Technical Bulletin

Number 124
March 1983

Cylinder Service Kit 673514

Model: 45C Load Push/Pull with Sheet-Sav™ option Serial No. 670203 and 672356

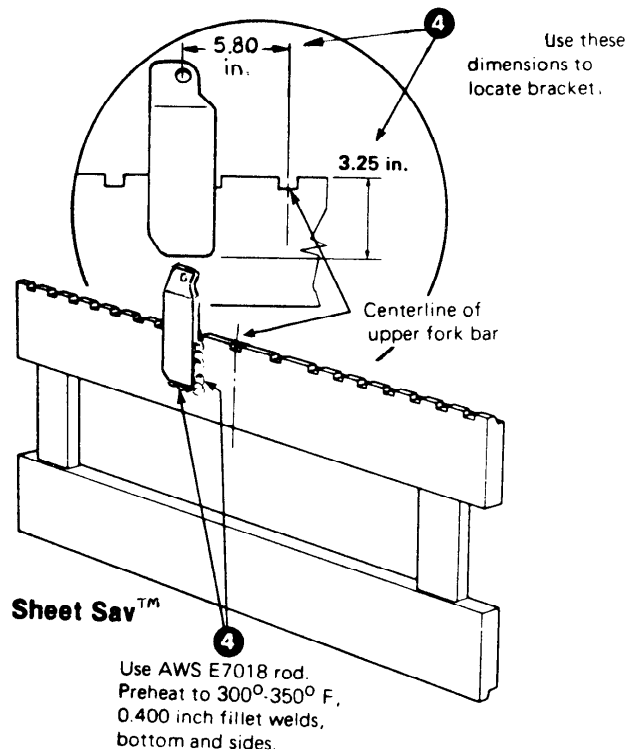
Problem: Sideshift cylinder stroke is excessive causing possible weld failure on the cylinder anchor bracket.

Solution: Install cylinder service kit 673514 to limit the cylinder stroke and improve the cylinder rod end anchor. The kit contains two cylinder spacers and an anchor bracket. The anchor bracket requires welding.

- 1 Remove the attachment from the truck. Refer to Service Manual Form 5181A.
- 2 Remove the sideshift cylinder from the attachment.
- 3 Remove the old anchor bracket from the truck carriage. Grind the truck carriage smooth.
- 4 Locate the new anchor bracket on the truck carriage using the dimensions shown. Preheat the bracket and carriage to 300°-350° F. Weld only the bottom and sides of the bracket with a .040 inch fillet weld using AWS E 7018 rod.
